Subject: UniStar Nuclear Energy, NRC Docket No. 52-016
Response to Request for Additional Information for the
Calvert Cliffs Nuclear Power Plant, Unit 3,
RAI 218 and RAI 229, Stability of Subsurface Materials and Foundations

Response to NRC Request for Additional Information

**RAI 218 Questions 02.05.04-03, 02.05.04-09, 2.05.04-10 and 2.05.04-15
and**

RAI 229 Questions 02.05.04-17 and 02.05.04-19,

Figure 1
Plastic Points at El. 41.5 ft On Top of Layer IIb-1

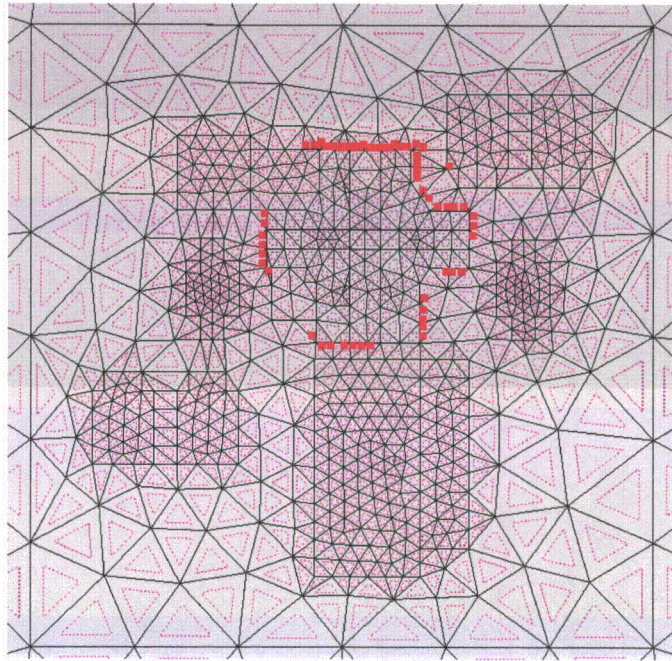
Section 2.5.4.5.2 indicates that most Category I structures will be founded on the top of Stratum IIb cemented sand layer. In Section 2.5.4.2.1.3, the layer IIb is further divided into three sublayers: silty sand layer with SPT N value greater than 20; clayey sand layer with N value smaller than 20; and poorly-graded sand to silty sand layer with N value greater than 20. The shear wave velocity of the layer IIb shows great variation, ranging from 560 to 3,970 ft/s. In addition, the shear strength property of the IIb is only based on very limited laboratory test results (one triaxial test for sublayer IIb-1 and two tests for sublayer IIb-2). Because the properties of the load-bearing layer IIb directly affect the foundation stability, the applicant is requested to explain how specific soil parameters for this layer were incorporated into relevant calculations (such as bearing capacity, settlement, SSI and GMRS), and discuss how the soil shear strength property for this layer was characterized based on limited testing results. In addition, describe how the variability was accounted for in the soil parameters for layer IIb in the above analyses.

Soil properties were determined based on test results conducted for materials in Calvert Cliffs Nuclear Power Plant (CCNPP) Unit 3 powerblock area. If no information is available for the CCNPP Unit 3 powerblock area, results for the entire site were used. From the data selected, average values were calculated and used in the analyses. As mentioned in the question, data is limited particularly for shear strength of Layer IIb. However, the settlement calculations are not expected to be significantly impacted by the shear strength, since the deformation is observed mostly in the elastic range (Figure 1). The impact of the shear strength variability is further discussed in the response to RAI 218 Question 02.05.04-15 Part 2.

Analyses related to soil-structure interaction (SSI) and ground motion response spectra (GMRS) are sensitive to the selected best estimate of the shear wave velocity profile and the shear modulus and damping strain dependant degradation curves. The variability of shear wave velocity is analyzed in CCNPP Unit 3 FSAR Section 2.5.4 and further discussed in the responses to RAI 218 Question 02.05.04-15 Part 2 and to RAI 229 Question 02.05.04-17 Part 3. The development of the best estimate soil profile accounts for the totality of the measurements at the site. Amplification analysis to develop the GMRS incorporates random variability of the shear wave velocity profile. This approach covers the variability observed in the field. The strain dependant curves for shear modulus and damping were selected from site specific Resonant Column Torsional Shear (RCTS) tests and random variability is also incorporated within the amplification analysis. It is relevant to note that the GMRS at the CCNPP Unit 3 site presents a Peak Ground Acceleration (PGA) of 0.08 g and that the site specific safe shutdown earthquake (SSE) is a broad band spectra anchored at 0.15 g which almost doubles the GMRS. Soil-structure interaction is based on a deterministic analysis that uses three sets of strain dependant shear modulus and damping. These three sets result from the amplification analysis, which already incorporates the variability in shear wave velocity. In conclusion, the variability of the parameters that affect the estimation of the GMRS, SSE, and profiles for SSI has been accounted for in

Figure 2
Slope/W Bearing Capacity Failure Surface – Average Parameters

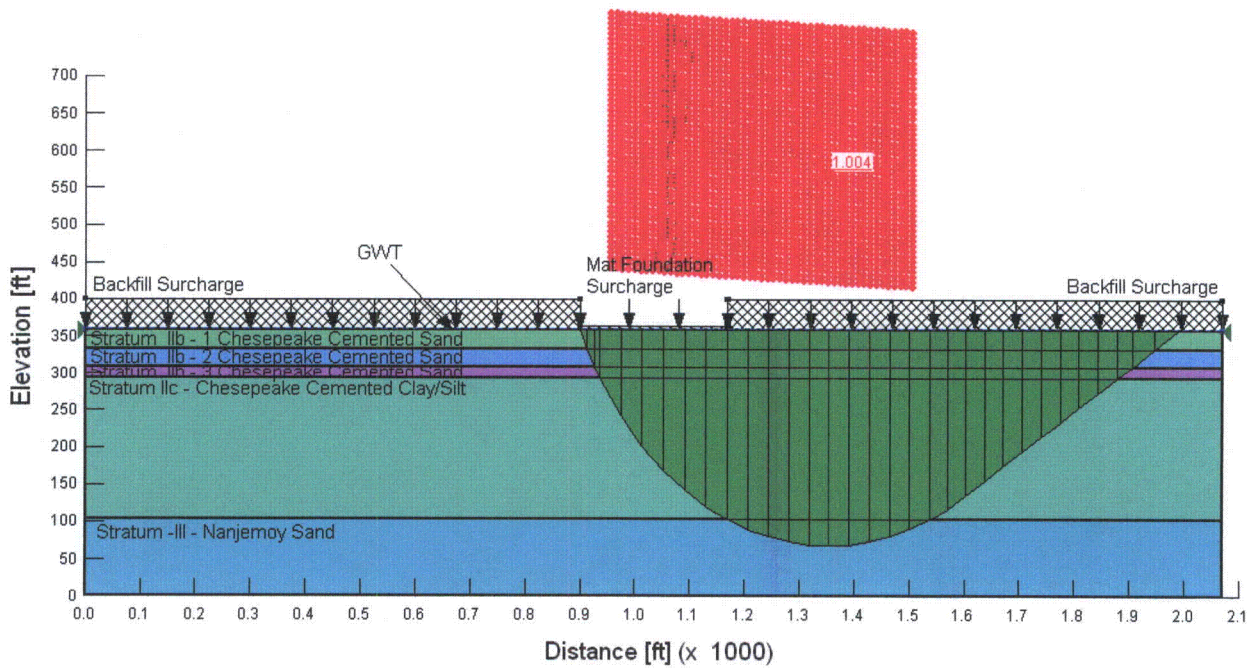
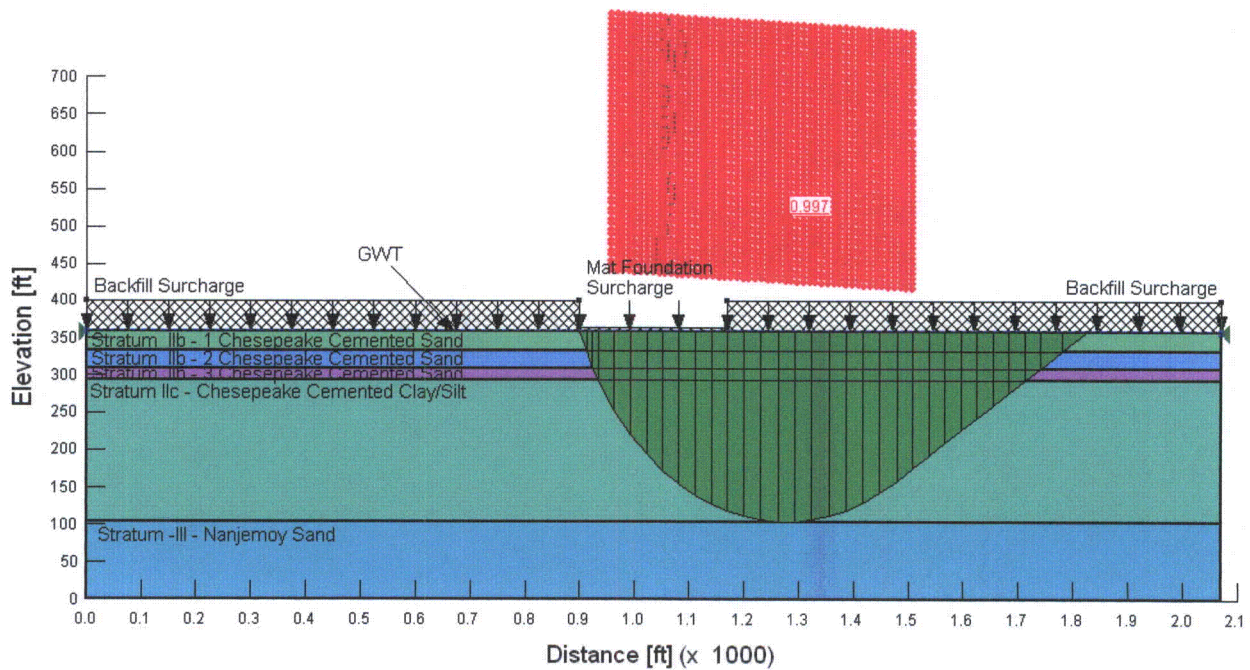
Section 2.5.4.10.1 states that three cases were considered during bearing capacity calculations. For the general case, the bearing capacity equation for homogeneous soil was used by applying weighted average values of soil parameters in the analysis, with the weight factors based on the relative thickness of each stratum within a specific depth. For the case of a footing supported on a dense sand stratum over a soft clay stratum, Meyerhof's model (Meyerhof, et al., 1978) was used to estimate ultimate static bearing capacity. Since the results of the bearing capacity analysis were controlled by the models, assumptions and parameters, the applicant is requested to:

1. Provide details on how the weight factors were determined for all subsurface soil strata;
2. Clarify and justify if soil compressibility was considered during the analysis since a clayey sand layer (Layer IIb2) is presented;
3. Discuss whether the dimension of a structure will affect the analysis results for footing supported on a dense sand stratum overlying on a soft clay stratum, because the Meyerhof model is based on the assumption that one dimension of the rectangular foundation is much larger than the other. Also, please clarify why the equation of q_{ult} presented in page 2-1252 is different from Meyerhof's equation by a factor of 2.

The failure surfaces obtained using Slope/W software, for average and lower bound soil strength parameters, are shown in Figure 2 and Figure 3. The soil profile and strength properties listed in Table 1 and Table 2 were considered in the analysis. Ultimate bearing capacity was obtained by increasing the foundation load until failure was reached (i.e. a Factor of Safety (FOS) = 1.0). The Morgan-Price method was used in the calculations.

The depth of the slip failure surface is approximately $1B$ for the average parameters case, and it is reduced to approximately $0.93B$ for the lower bound case. Both values are in agreement with theoretical results and with the influence depth that was considered in the Vesic method.

Figure 8
Three Zoned Initial Topography,
El. 60 ft for Zone I, El. 80 ft Zone II, and El. 105 ft for Zone III.

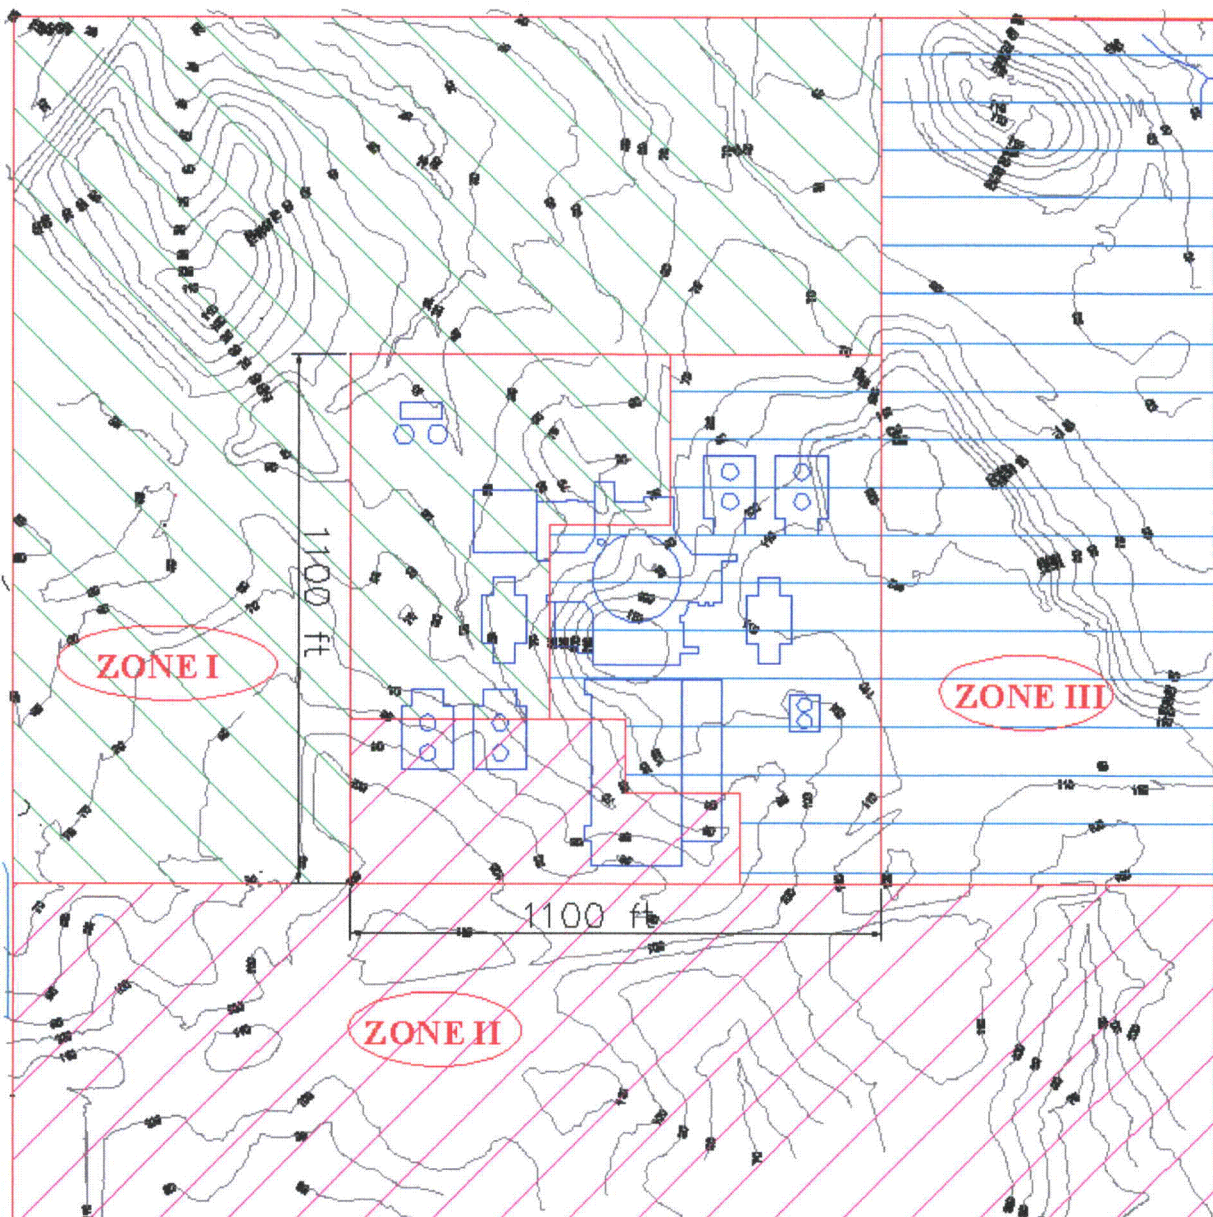
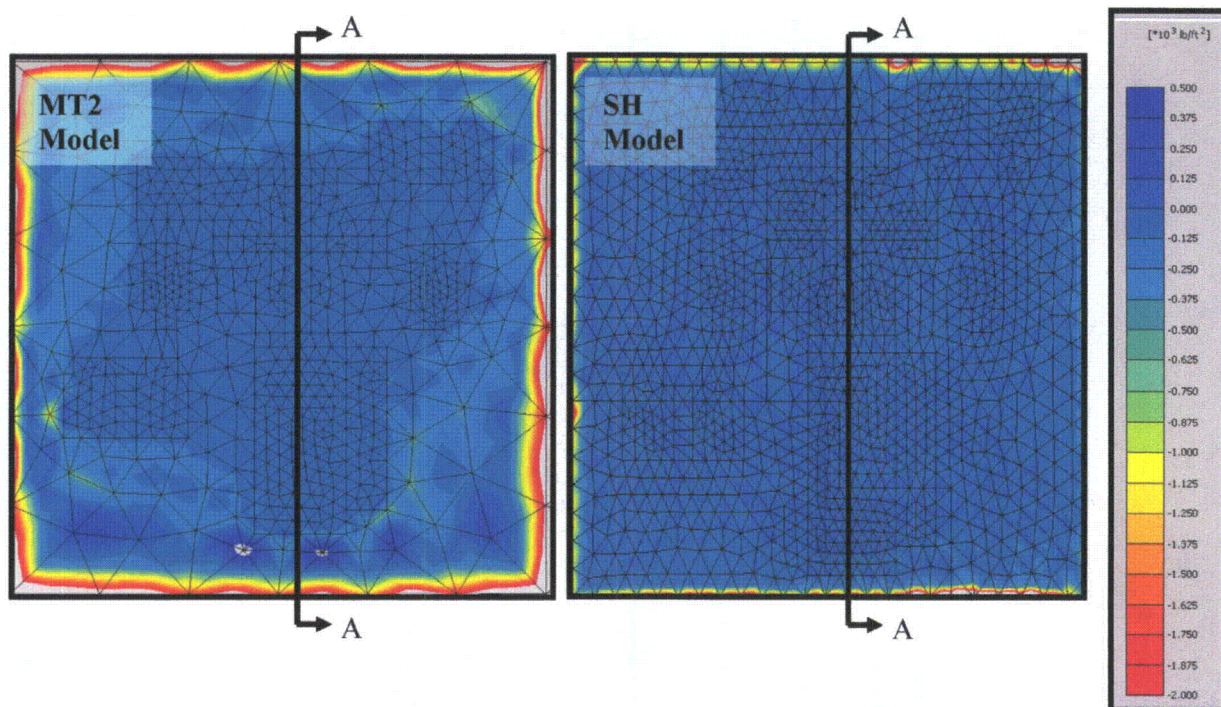
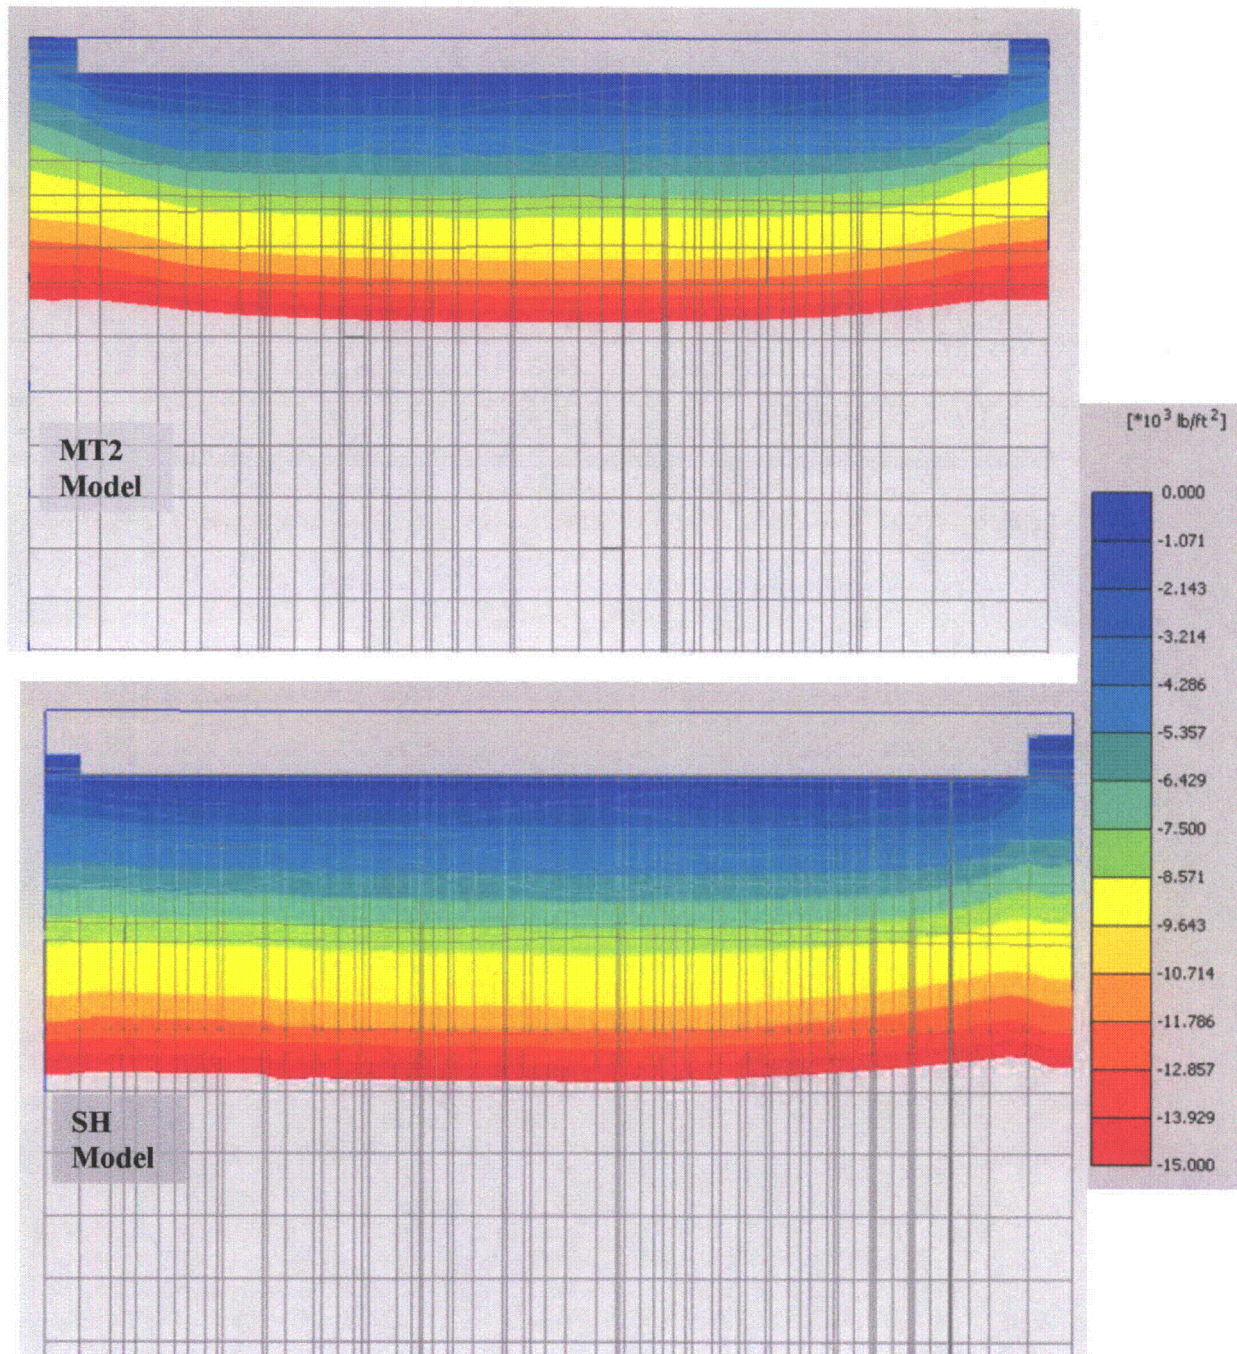
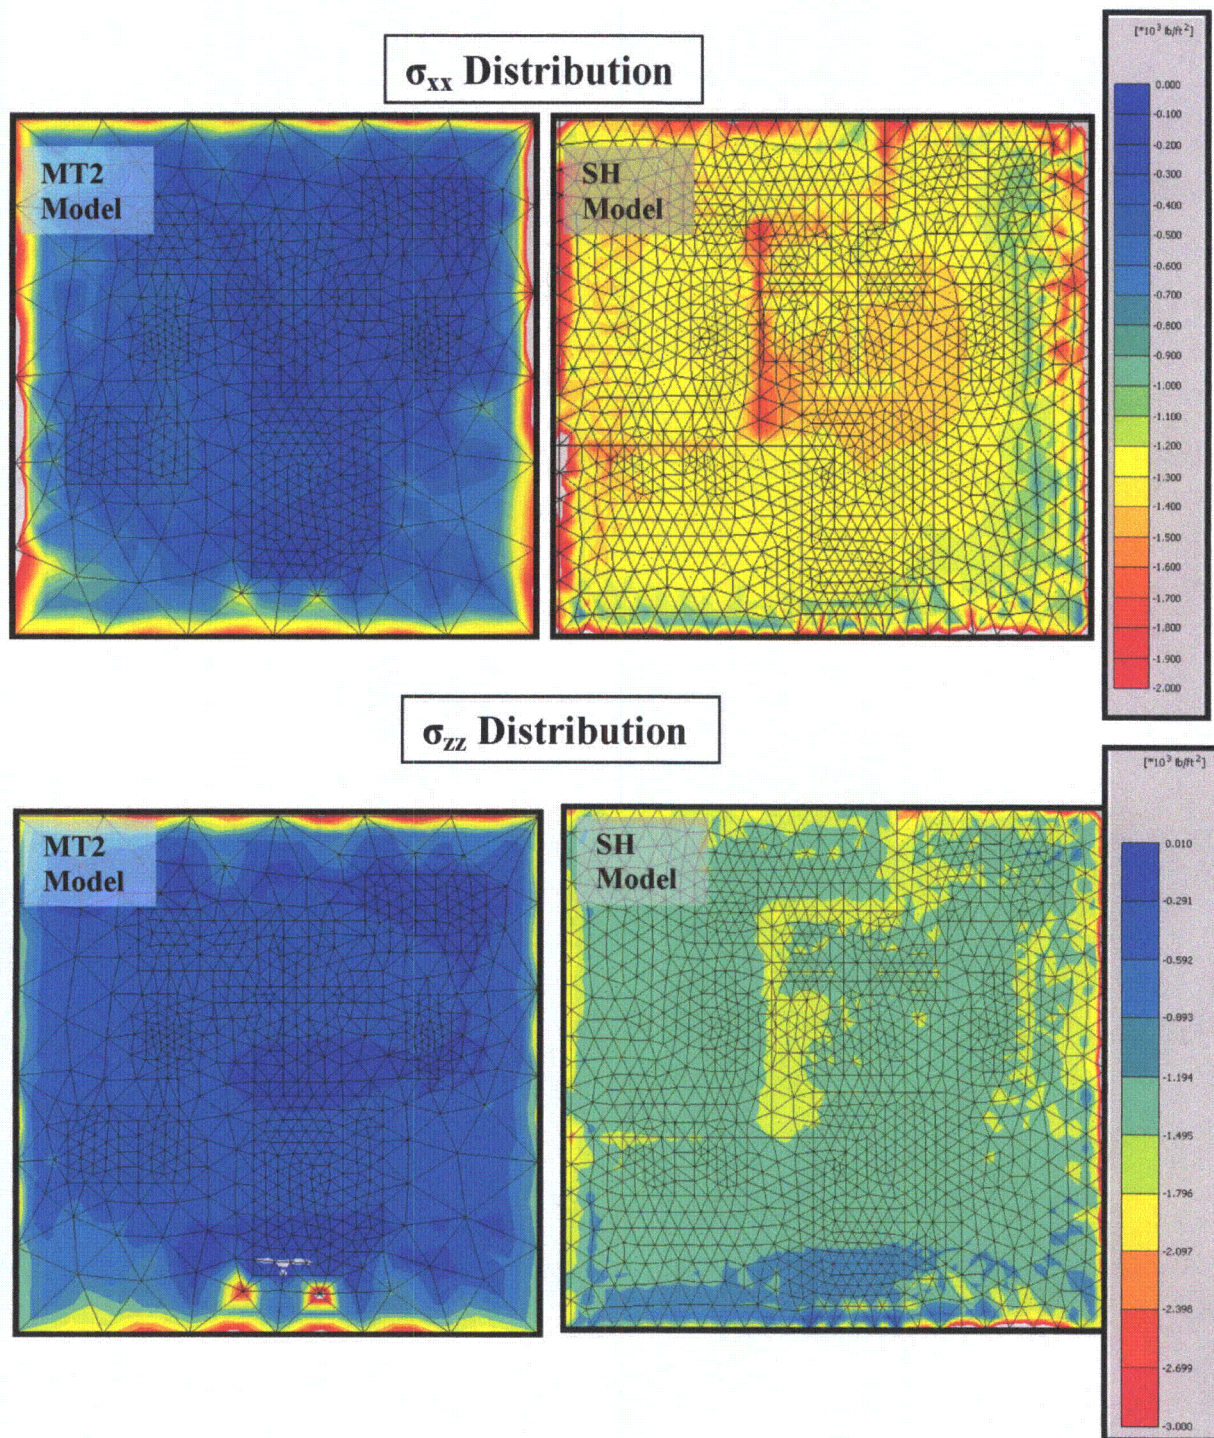
FSAR Subsection 2.5.4.10.2.2 states that the initial effective stress conditions used in the FEM settlement model were in "accordance with the post-excavation overburden geometry" with an average surface elevation of 83 ft. In addition, the model assumed that excess pore water pressures created during excavation and dewatering are fully dissipated. It also presents the settlement analysis results, total and differential settlements for individual seismic Category I structures, based on a series of static loads applied to assimilate the assumed construction schedule, without consideration of dynamic loads created by seismic events.

1. Please explain the adequacy of the initial stress conditions selected in your FEM settlement calculation.
2. Please evaluate the possibility of any additional settlement caused by seismic event at the site.
3. Please address the effects of soil parameter variation and spatial variability on your settlement analysis.
4. Please address differential settlement between the nuclear island and adjacent structures, and compliance with the U.S. EPR standard design.
5. Please justify the assumptions, especially the determination of stress increases in each layer, used in the hand calculation of settlement you performed.

Initial vertical effective stress distribution underneath/around a foundation directly affects the magnitude of foundation settlement. The vertical stress distribution is associated with the post-excavation geometry assuming that (a) excess pore pressure generated in Stratum IIc due to excavation is dissipated, and (b) excavation covers a large zone (1100 ft by 1100 ft). Following the excavation, stresses associated with unloading are induced at the excavation base (El. 41.5 ft). As a result of these stresses, heave is observed. As the immediate component of the heave takes place and the excess pore pressure due to excavation dissipates, the stress at the excavation base becomes close to zero. The excavation is expected to be completed in approximately 6 months, which is enough to dissipate at least 90% of the excess pore pressure due to the excavation. This forms the basis for the development of the 3D finite element model Middle Topography 2 (MT2) discussed in Section 2.5.4.10 of the CCNPP Unit 3 FSAR. The model assumes a flat ground surface at El. 83 ft, excavated to El. 41.5 ft, and loaded with structural fill and building loads. The adequacy of the stress conditions implemented in this model can be checked by developing another model that simulates the in situ initial topography more closely. To that end an independent model based on the Soil Hardening constitutive model (SH) has been developed. The excavated area of 1100 ft by 1100 ft is divided into three zones with different elevations, El. 60 ft, El. 80 ft, and El. 105 ft (Figure 8).

The SH model may be used to test the adequacy of the initial stress conditions implemented in the MT2 model. Figure 9 indicates the initial vertical stress distribution at the base of the excavation for both MT2 and SH models. As expected, the initial vertical stress (post-excavation) is around zero at the excavation base for both models. Figure 10 depicts the vertical stress distribution along the cross-section AA as given in Figure 9. Both models produce very similar initial vertical stress distributions.

As stated previously, the SH model utilizes the Hardening Soil constitutive model which varies the soil stiffness as a function of mean effective stress. In other words, differences in two lateral stress components may also impact the settlement results. Figure 11 shows the lateral stress components at the base of the excavation, where lateral stresses obtained from SH model are larger. The stiffness used by the MT2 model is not influenced by the magnitudes of lateral stresses, whereas the SH model uses these stresses to compute the mean effective stress and the soil stiffness.
